Access Compliance Report Public Rights-of-Way (Curb Ramps)

Main Street: SHERBROOK_DR Cross Street: PROSPECT_AVE Location: NW

ADA ID: RPRK220121134322 Ramp Type: Type 4 - Parallel Initial Pass/Fail: Fail Overall Compliance: No Severity Score: 2

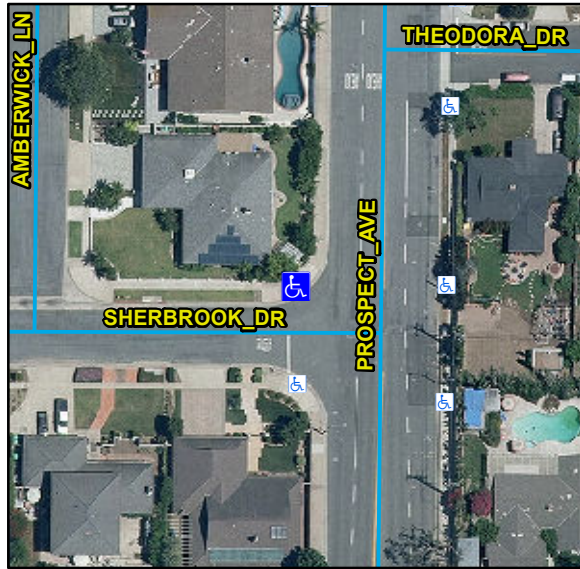
Compliance	Description	Data	Compliance	Description	Data
N/A	Ramp Length LT (in)	115	N/A	Ramp Length RT (in)	118
Yes	Ramp Width LT (in)	118	Yes	Ramp Width RT (in)	118
Yes	Ramp Run Slope LT (%)	2.4	Yes	Ramp Run Slope RT (%)	8.3
Yes	Ramp Cross Slope LT (%)	1.5	No	Ramp Cross Slope RT (%)	4.4
N/A	Landing Present	N/A	N/A	DWS Provided	N/A
N/A	Landing Length (in)	N/A	N/A	DWS Contrast	N/A
N/A	Landing Width (in)	N/A	N/A	DWS Length (in)	N/A
N/A	Landing Run Slope (%)	N/A	N/A	DWS Full Width	N/A
N/A	Landing Cross Slope (%)	N/A		DWS Offset Type	N/A
N/A	Landing Movement Obstructed?	N/A	N/A	DWS Offset Left (in)	N/A
	Landing Movement Type	N/A	N/A	DWS Offset Right (in)	N/A
N/A	Landing Shared	N/A			
N/A	Clear Space	Yes			
N/A	Clear Space To Crosswalk (in)	N/A			
N/A	Marked Crosswalk 1	No	N/A	Marked Crosswalk 2	No
	Crossing 1 Direction	S		Crossing 2 Direction	E
	Marked Crosswalk 1 Width (in)	N/A		Marked Crosswalk 2 Width (in)	N/A

Remove & Replace Curb Ramp With Two New Directional Ramps or Equivalent.
